PM The Glitch and The Fix

One Too Many...

Overview: An installer learns that a hydraulic separator can replace a pair of closely spaced tees and an air separator. He installs the hydraulic separator as shown below, keeping what he feels are standard details for a primary/secondary system.

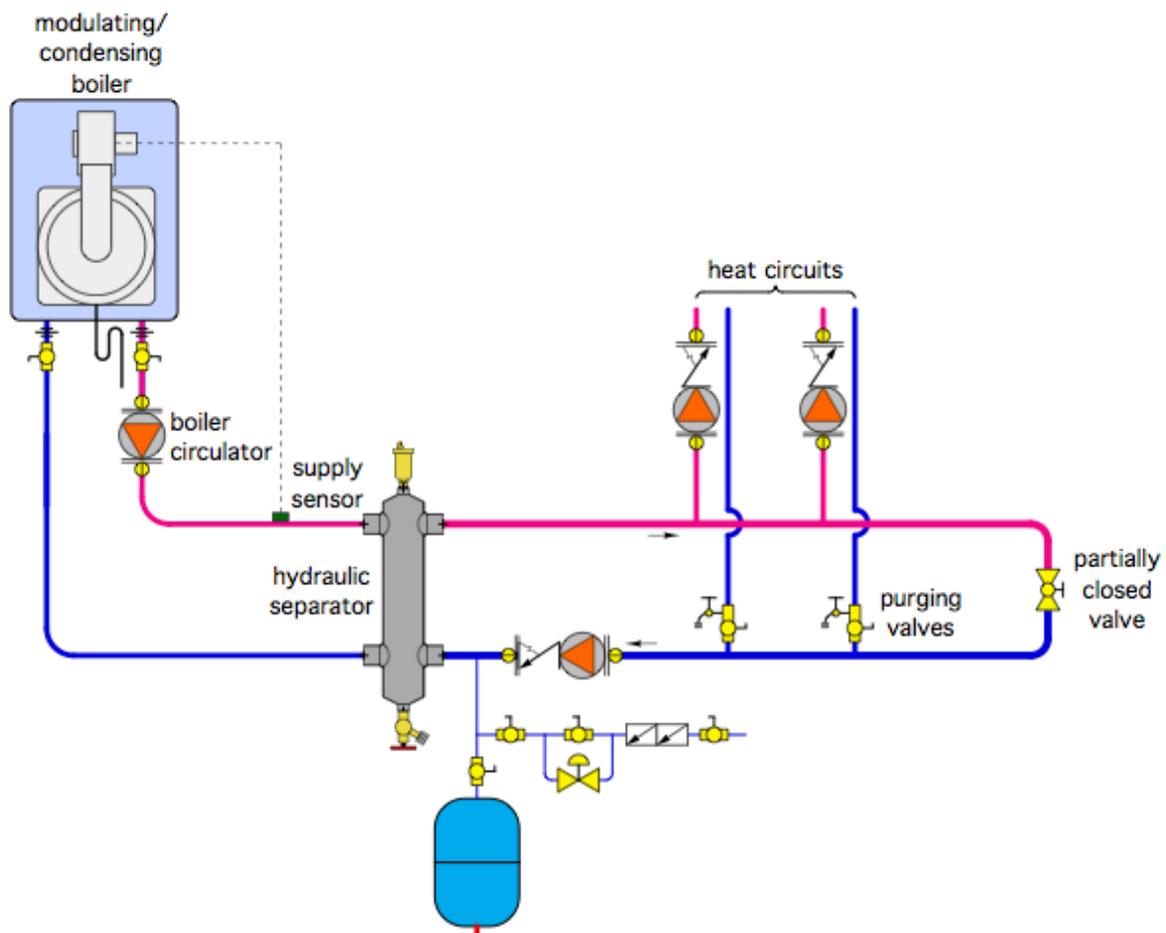
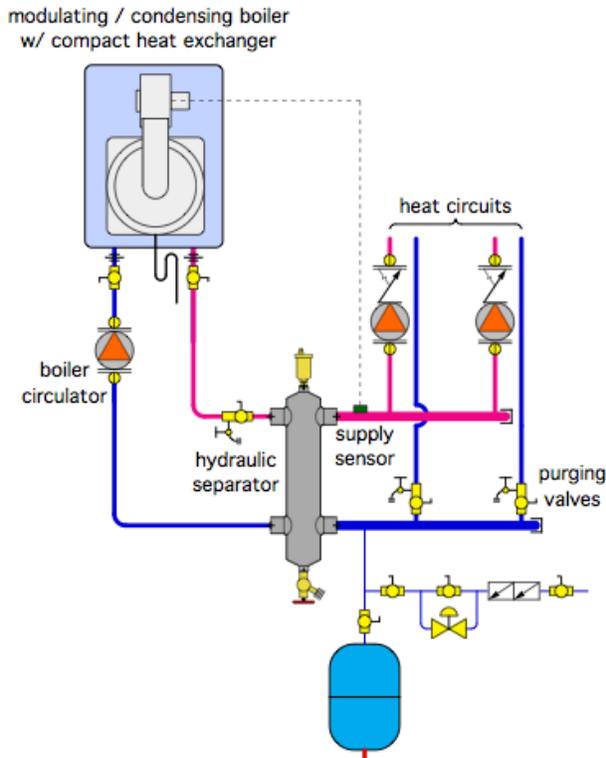
Exercise: Can you spot at least four errors in this layout?

1. The boiler circulator should be positioned to push flow into a modulating/condensing boiler with a compact heat exchanger. Such boilers typically generate significantly higher flow resistance relative to traditional boilers with cast-iron heat exchangers. The position of the boiler circulator in the glitch drawing decreases boiler pressure whenever the circulator is operating. If the water temperature in the boiler is high enough, steam flashing may occur.

2. The supply temperature sensor placement shown in the glitch drawing will not detect the water temperature supplied to the distribution system. If the flow rate on the right side of the hydraulic separator is higher than the flow rate on the left, mixing will occur within the separator. This will reduce the supply temperature to the distribution system. Ideally, boiler modulation should be based on the load side supply temperature and, thus, the temperature sensor should be moved to the position shown on the fix drawing.

3. There is no need of a "primary loop" on the load side of the hydraulic separator. The details shown in the glitch drawing not only use an extra circulator, they also induce a differential pressure between the top and bottom portions of the loop (due to head loss across the partially closed valve). This pressure differential will attempt to push flow through both load circuits whenever the primary circulator is operating. The fix is to eliminate the primary loop and simply use short, generously sized headers as shown.

4. Add a purging valve on the boiler circuit as shown in the fix drawing to provide efficient air removal from the boiler at start up.
